**WILLIAMSON COUNTY, TEXAS**

**CHANGE ORDER**

For Project: **WILLIAMSON COUNTY JAIL KITCHEN & PLUMBING REMODEL**  
 Date of Issuance: 7/10/2018  
 Contractor: STR Constructors, LTD.  
 Project Engineer: Talex, Inc.

This change order is due to the following:  
 PCO #37r1 - SPT Kitchen Credit & Addt Connection

# RISER

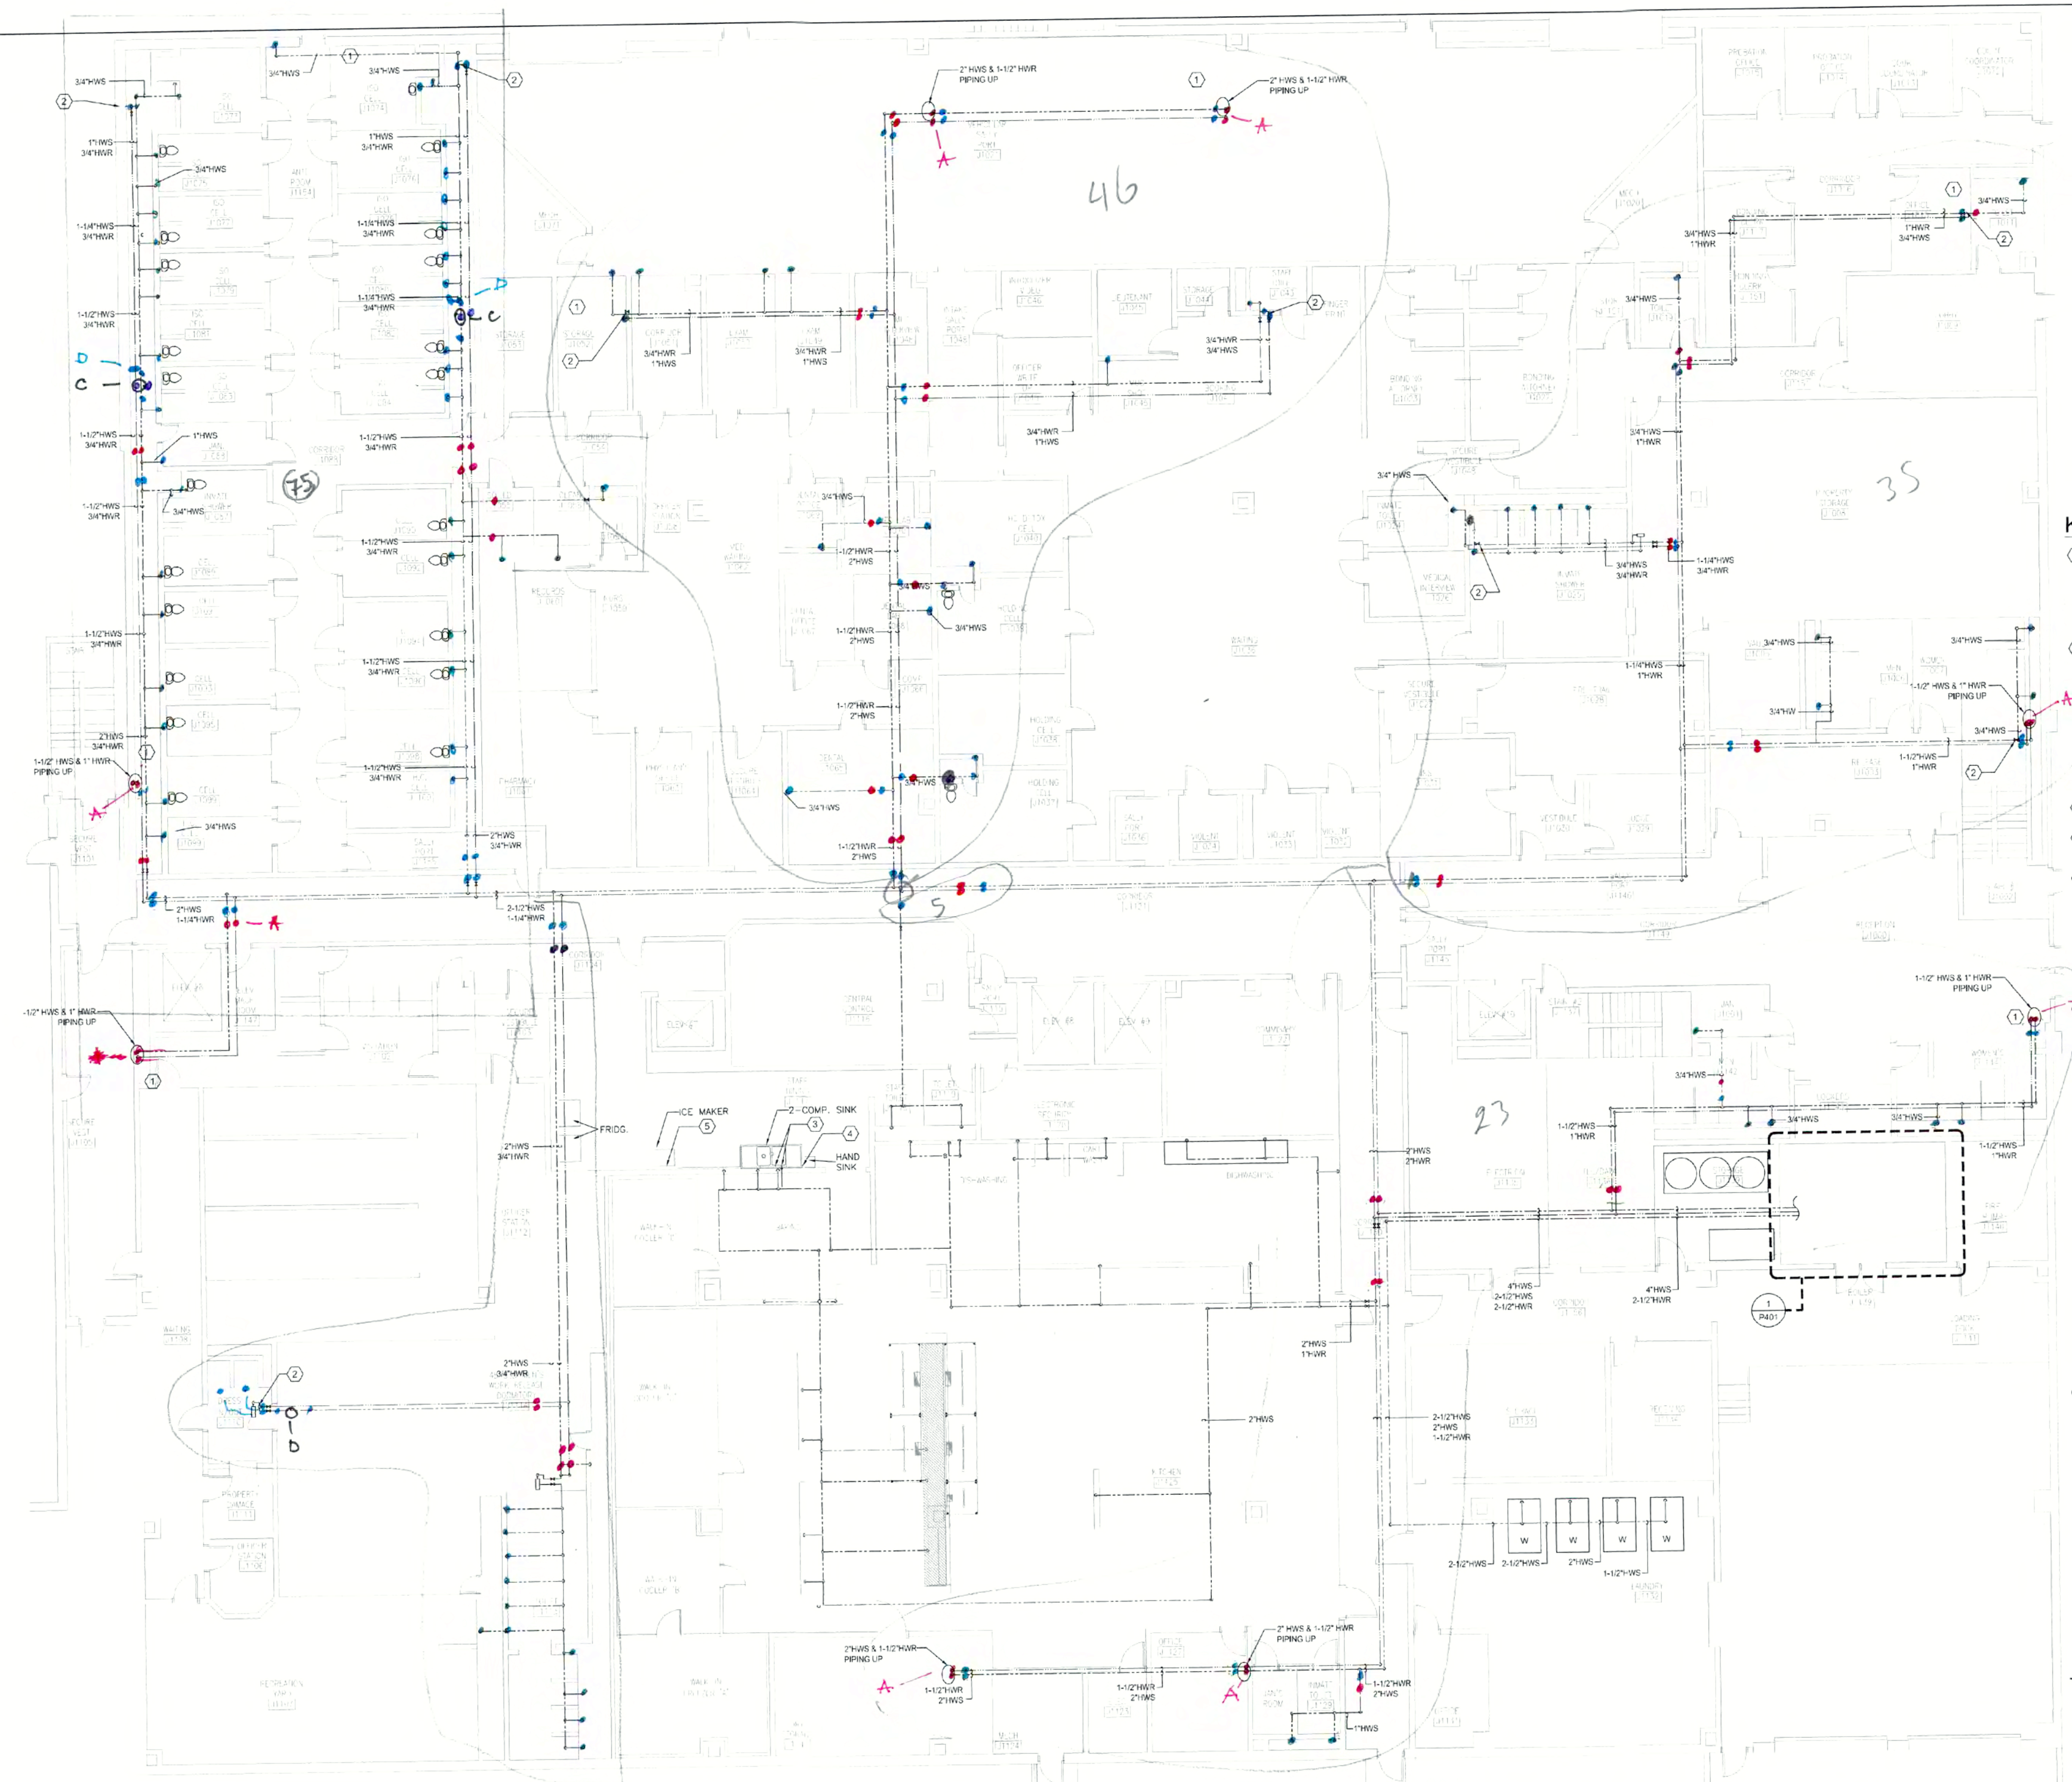
A = EXITS FOR RISERS  
 ● = EXITS  
 B = INTAKE FOR RISERS  
 ● = INTAKE  
 C = MIXING VALVE  
 D = TEMP-GAUGE  
 -I- CONNECTION

205 TOTAL CONNECTIONS  
 NOT INCLUDING RISER EXITS

1ST = 217  
 2ND = 248  
 3RD = 180  
 RISERS = 96  
 TOTAL 735

**P102**  
 SHEET

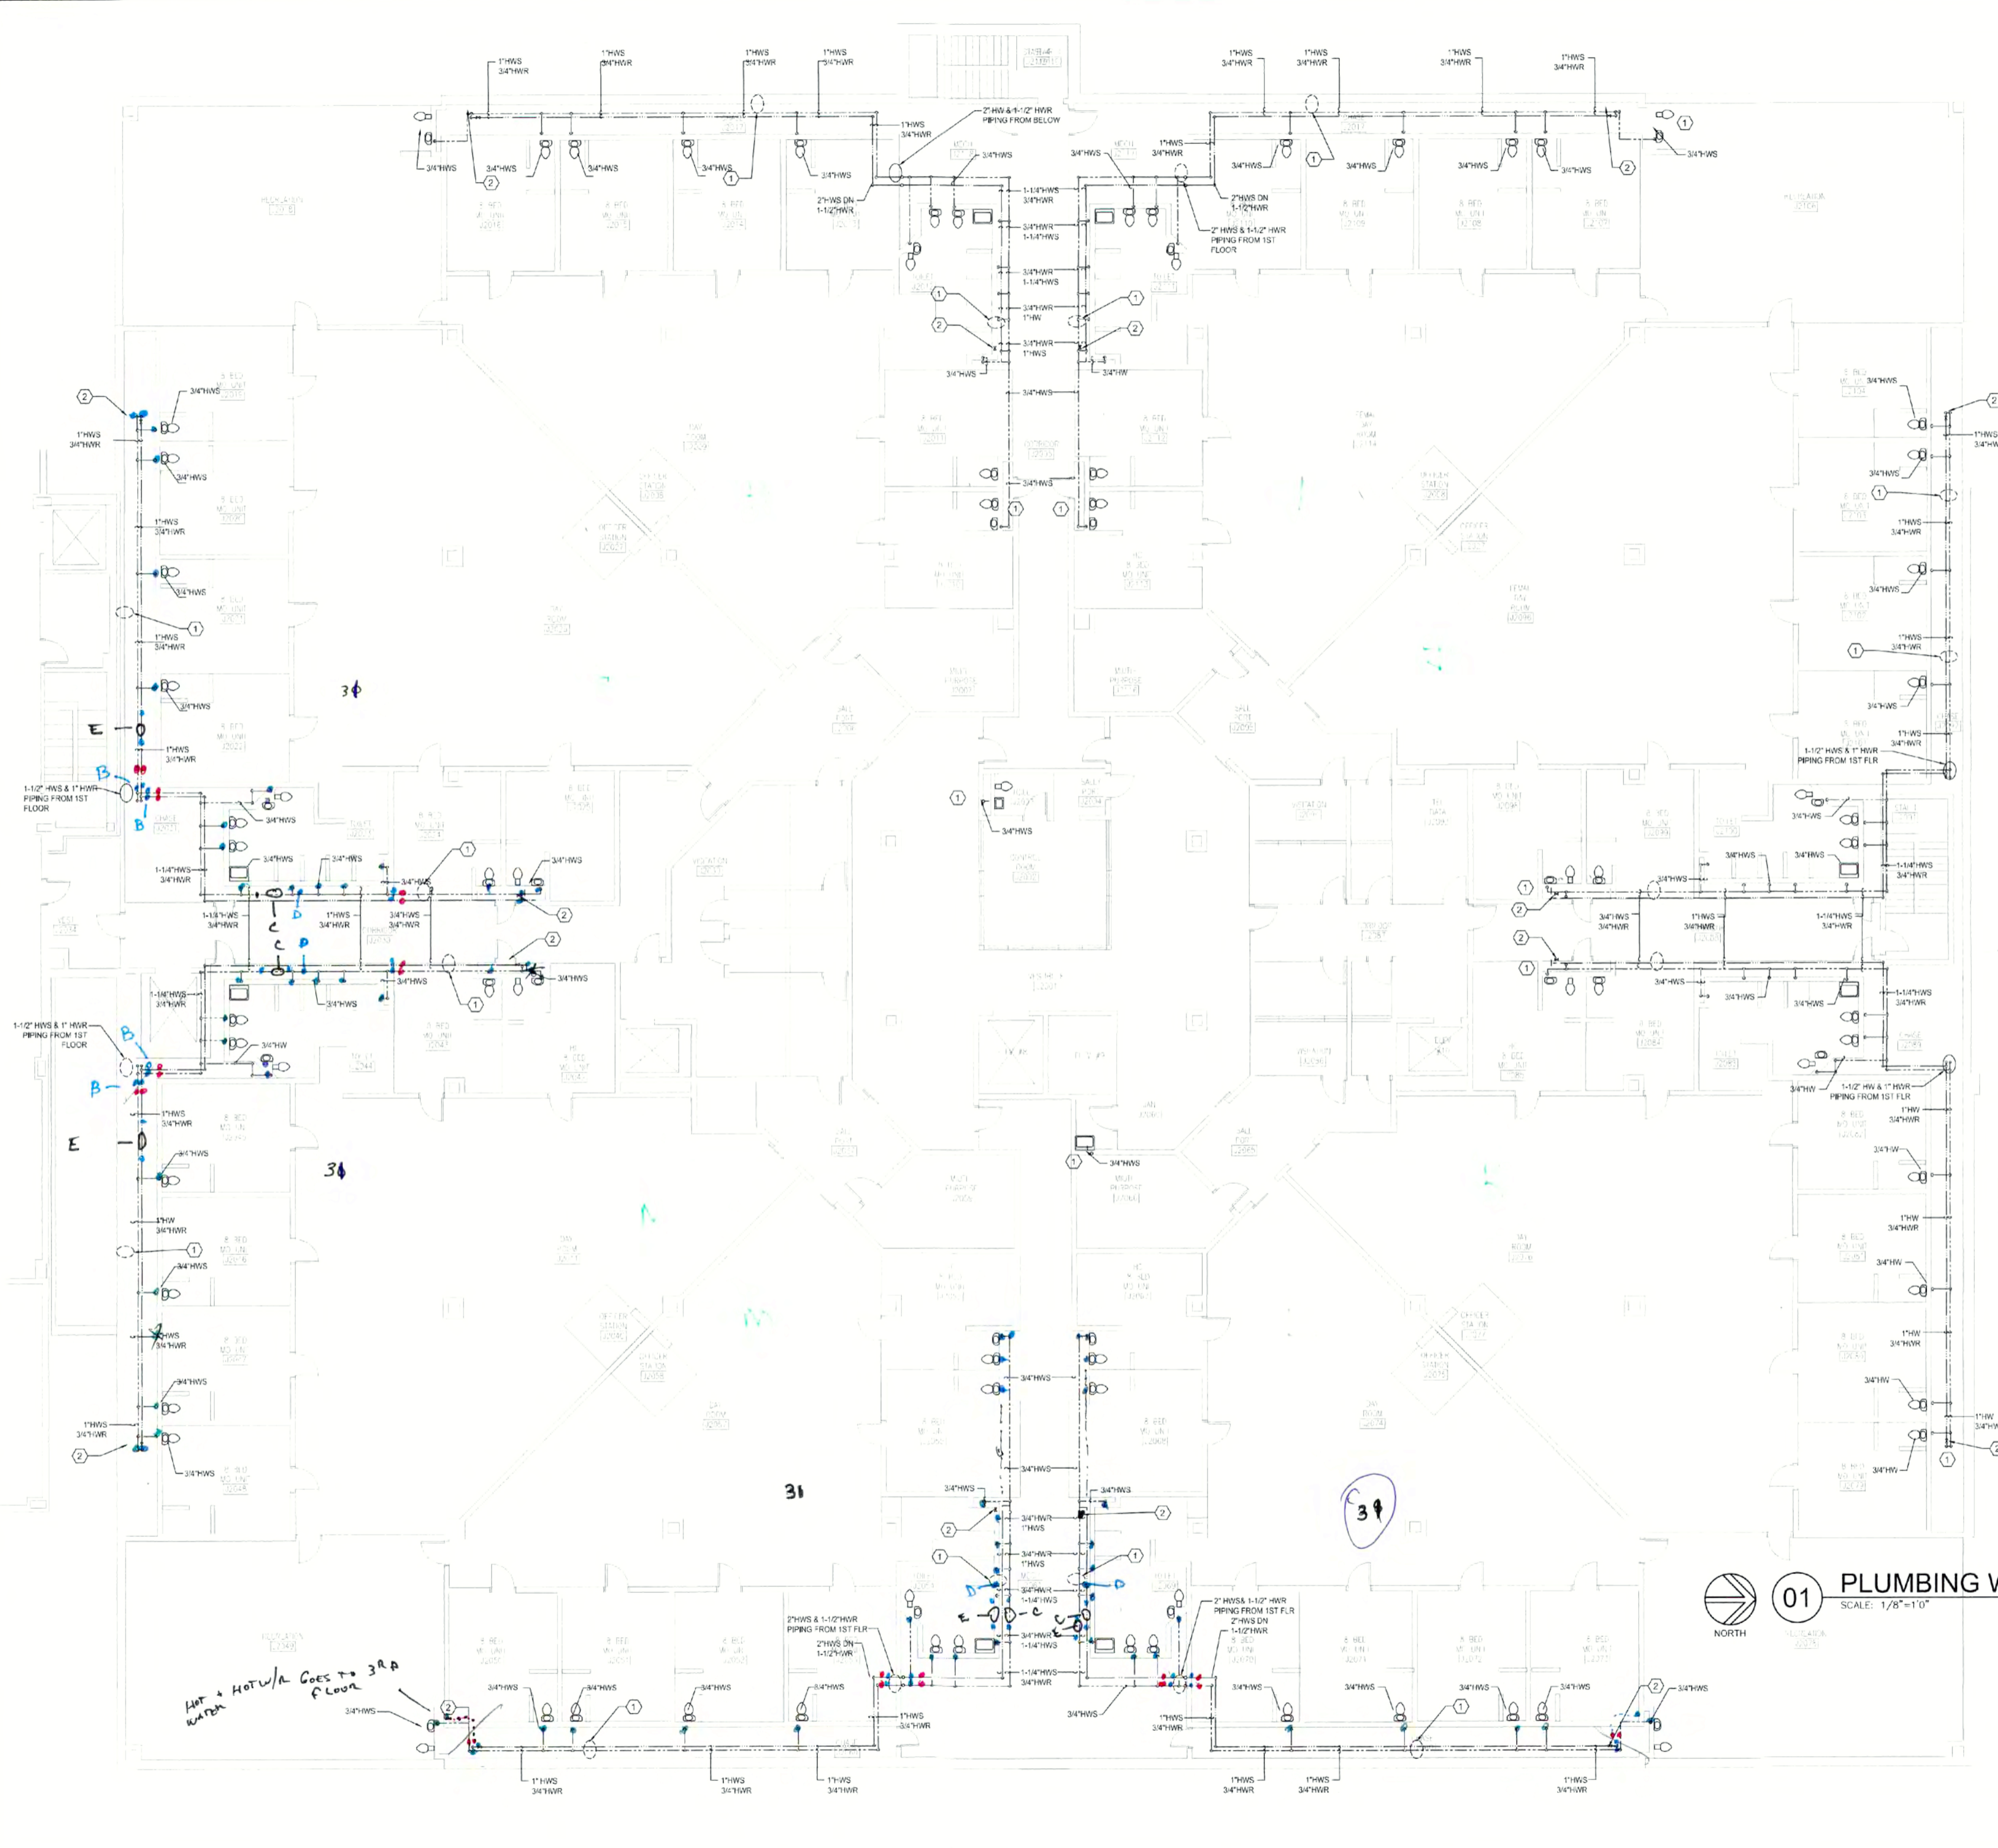
PODS M + L + H + I HAVE SAME LAY OUT.  
 PODS M L L EACH HAVE 31 CONNECTIONS  
 TOTAL FOR PODS M + L + H + I = 124 CONNECTIONS  
 PODS G + N + K + J HAVE SAME LAY OUT.  
 PODS G + N EACH HAVE 31 CONNECTIONS  
 TOTAL FOR PODS G + N + K + J = 124 CONNECTIONS  
 SECOND FLOOR CONNECTIONS = 248  
 NOT INCLUDING RISER CONNECTIONS

Hot + Hot W/A Goes to 3rd Floor

SHEET TITLE  
**PLUMBING  
WATER PLAN  
THIRD FLOOR**

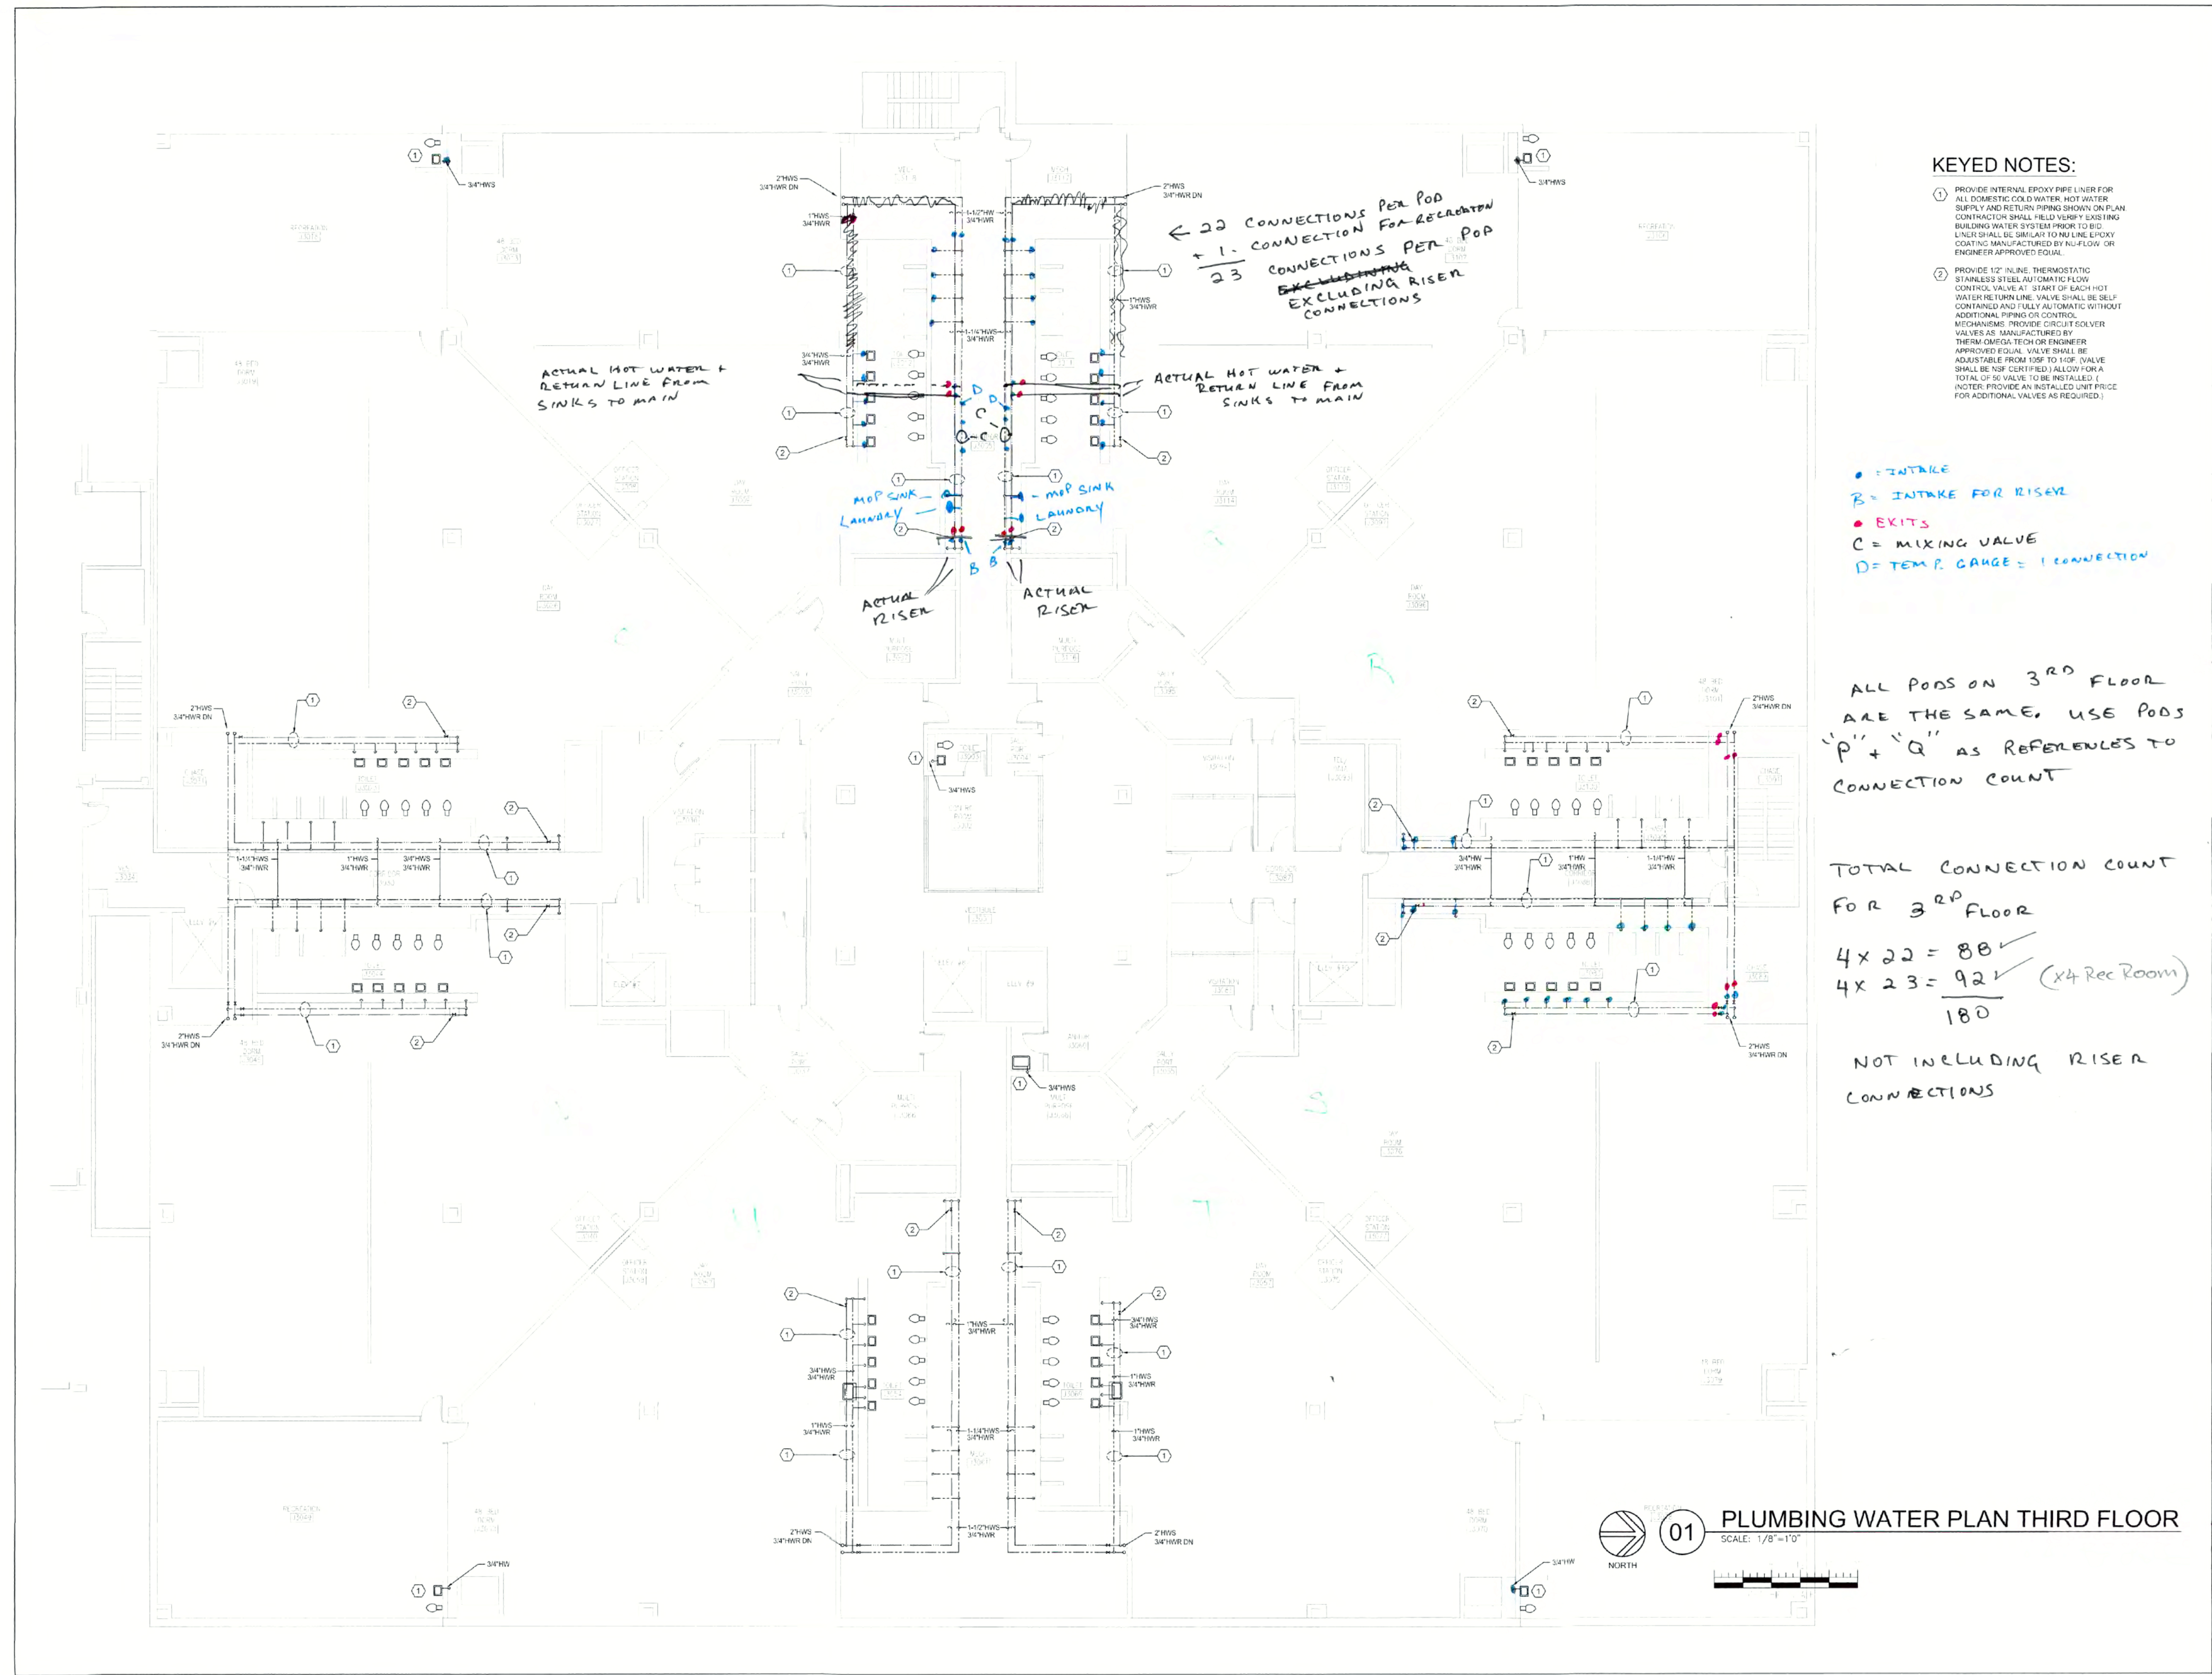
ALL PODS ON 3<sup>RD</sup> FLOOR ARE THE SAME, USE PODS "P" + "Q" AS REFERENCES TO CONNECTION COUNT

TOTAL CONNECTION COUNT FOR 3<sup>RD</sup> FLOOR

4x22 =	88 ✓
4x23 =	92 ✓ (x4 Rec Room)
	<hr/> 180

NOT INCLUDING RISER CONNECTIONS
